CALIFORNIA COASTAL COMMISSION

**STAFF REPORT: REGULAR CALENDAR**

APPLICATION NO.: 5-97-269

PROJECT DESCRIPTION: Construction of a 30 foot high, three-story, 6,906 square foot four unit apartment building with a 2,079 square foot garage with nine (9) parking spaces. The project includes 752 cubic yards of grading and landscaping.

EXHIBIT NO. 2
APPLICATION NO.
5-97-269
SITE PLAN
California Coastal Commission

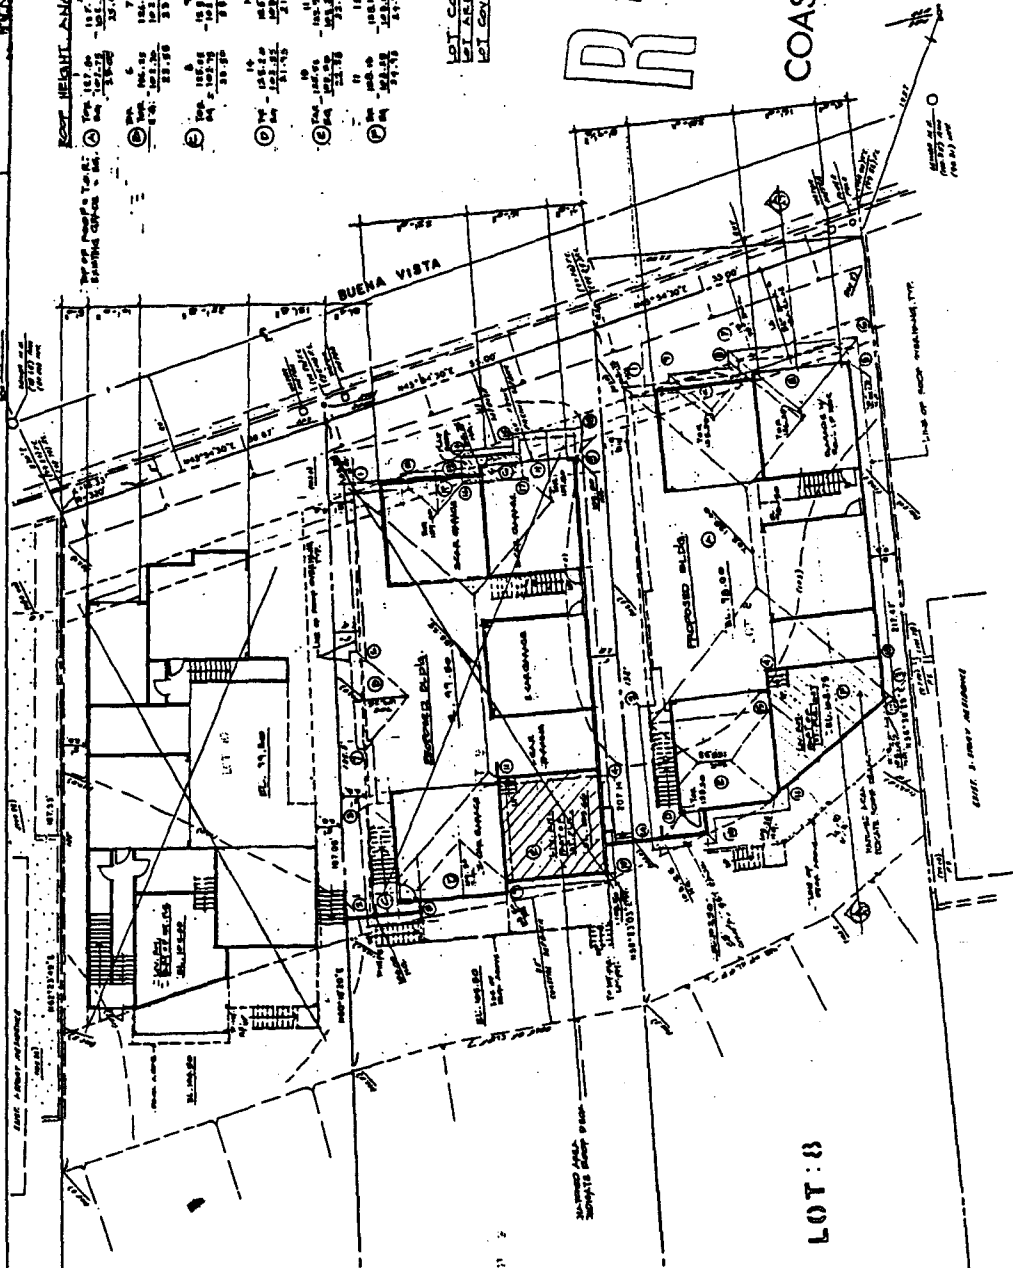
The coastal bluff edge is steep and poses a potential danger to future residents. Therefore, it is understandable that a fence be constructed for safety reasons to keep residents and guests away from the bluff edge. The plans submitted by the applicant show that their proposed five foot high

wrought iron fence would be located at the bluff edge. The findings of this staff report and the geotechnical report clearly show that the bluff edge is currently undergoing erosion and creep. Therefore, location of a fence at the eroding bluff edge is unacceptable and section "e" of special condition 3 requires that the fence must be set back at least five feet to allow for erosion. In addition, it is in the applicant's interest to design a fence which can be relocated in the event that it becomes threatened by erosion in the future.

- (e) The fencing located at the edge of the bluff shall be constructed of non-permanent materials (i.e., material other than concrete), shall be set back a minimum of five feet from the bluff edge and shall be designed so that it can be moved landward in the event of landslide.

EXHIBIT NO. 3
APPLICATION NO. 5-97-269
Aerial Photo
 California Coastal Commission

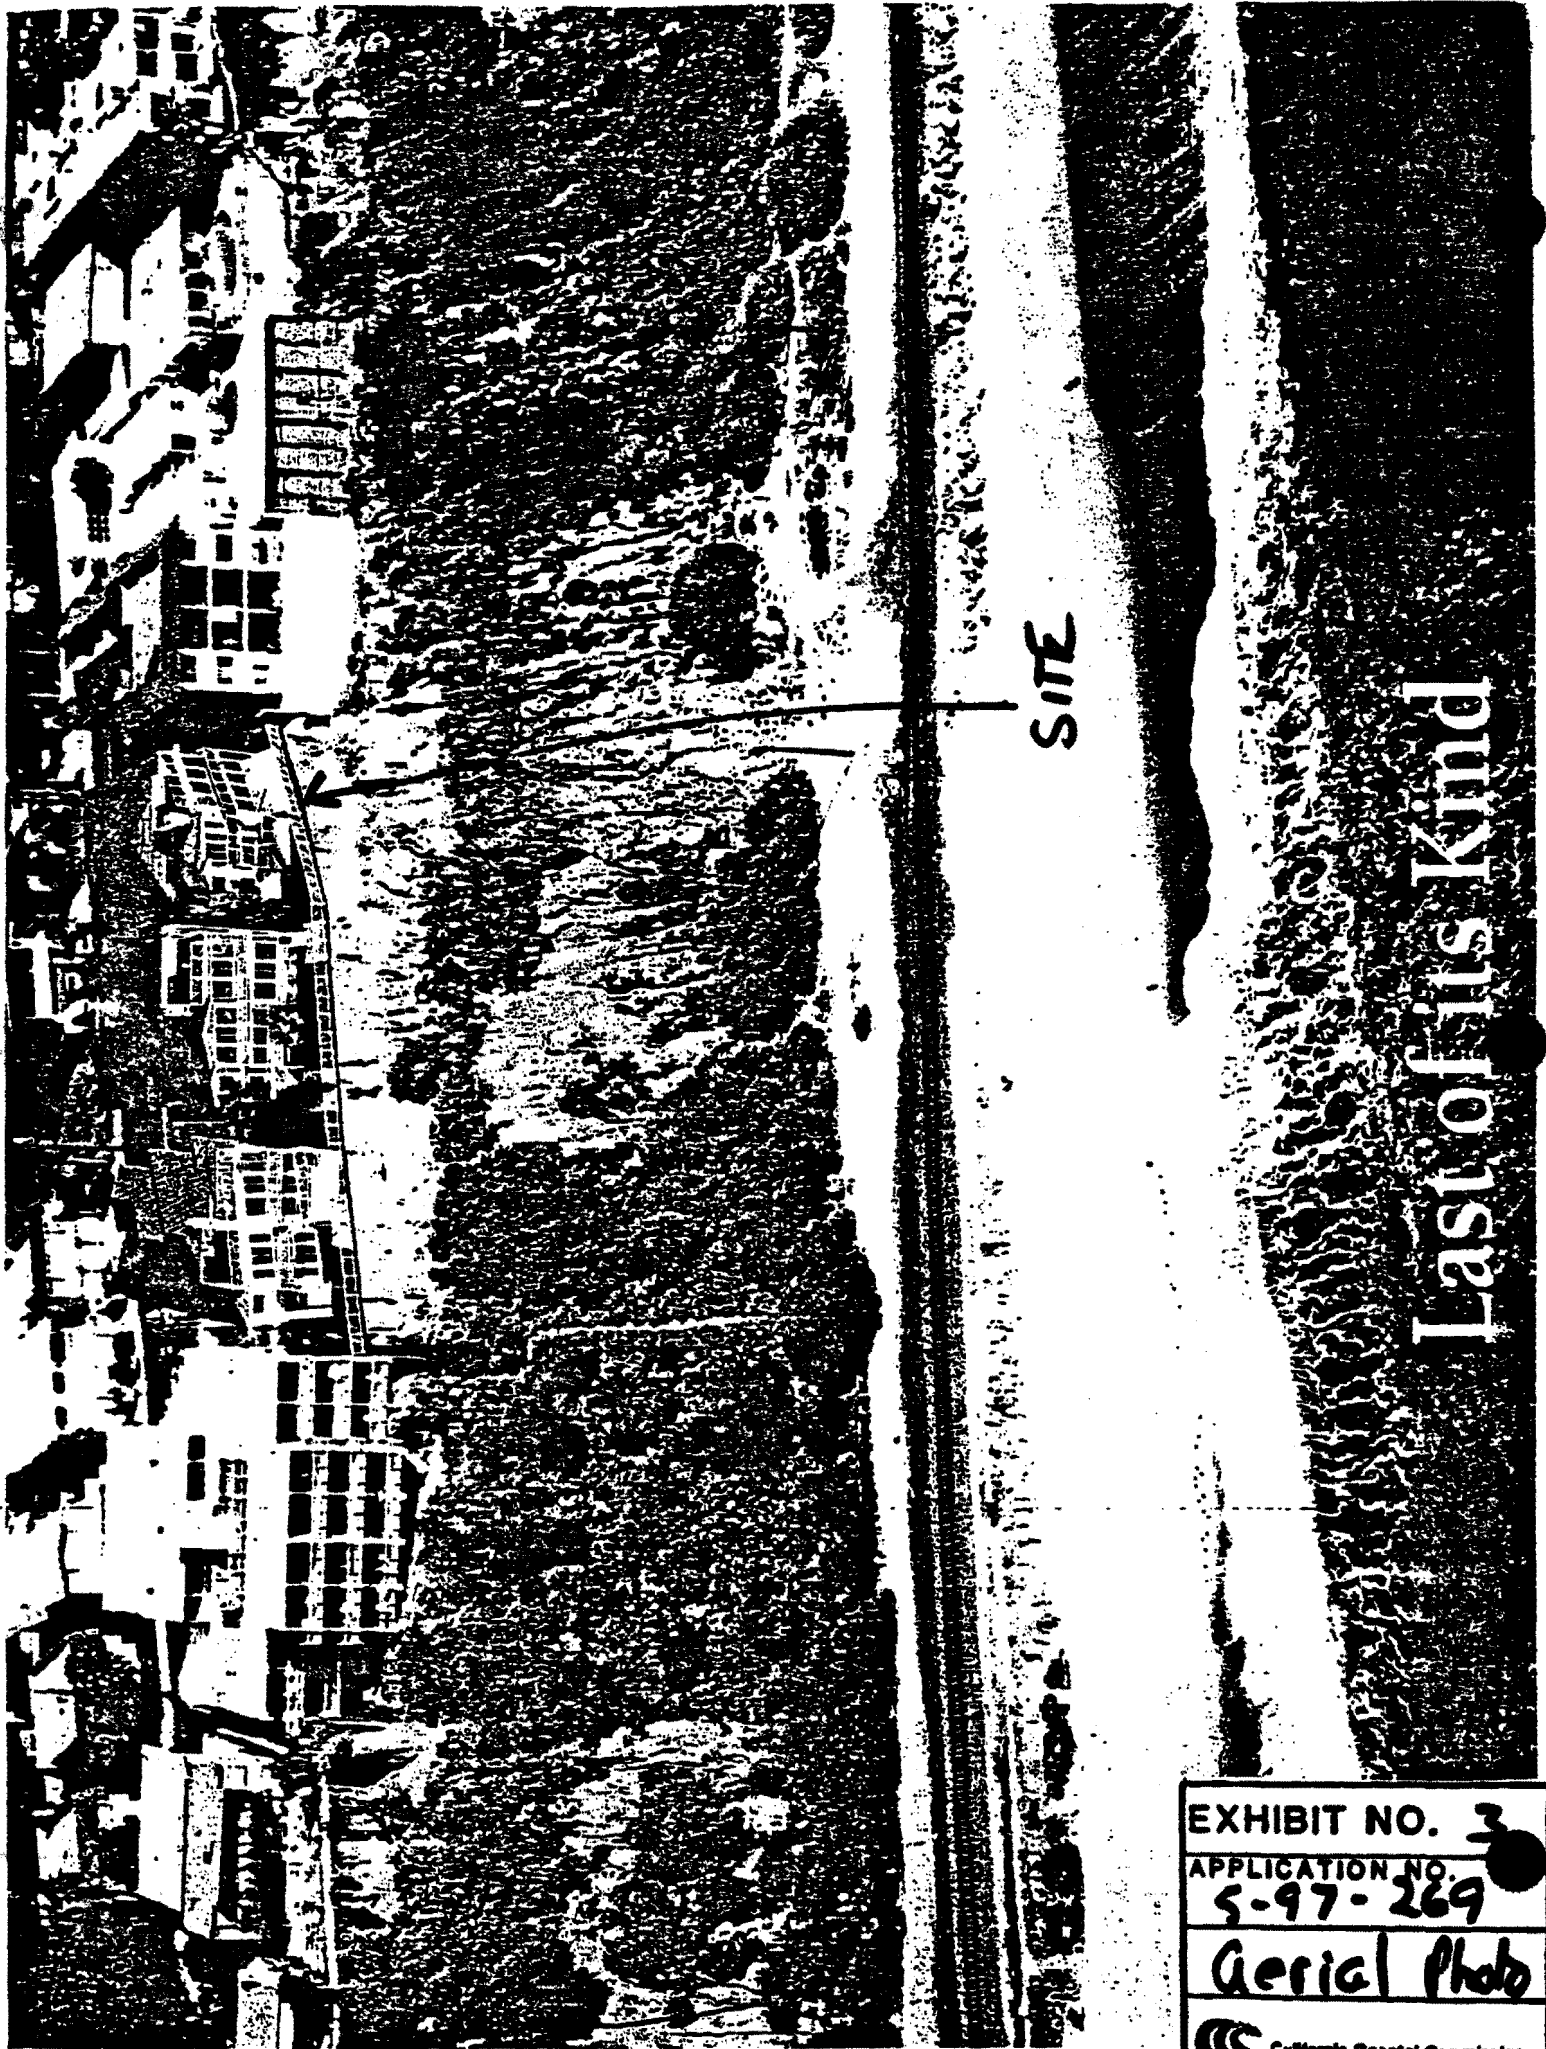
Exhibit 3 is an aerial view of the bluff showing what the proposed structure(s) will look like after they are built. The proposed structures are the three in the center of the aerial photograph. This application corresponds to the southernmost lot or the development on the right.

The aerial (Exhibit 3) shows that the bluff to the north and south of the proposed development is largely barren with a strip of vegetation running across the middle of the bluff. This strip of vegetation probably corresponds to where water is seeping out on the bluff face. This steepness of the bluff face at the top of the bluff and the lack of vegetation to hold down soils combine to make the top section of bluff particularly susceptible to erosion, creep and localized slope failure. The lack of vegetation holding down the soils and the steepness of the lower bluff increase the probability of block fall landslides.

Of the six existing structures in the aerial photograph only the residence at the far right (south) has non-improved open space between the primary structure and the bluff edge.
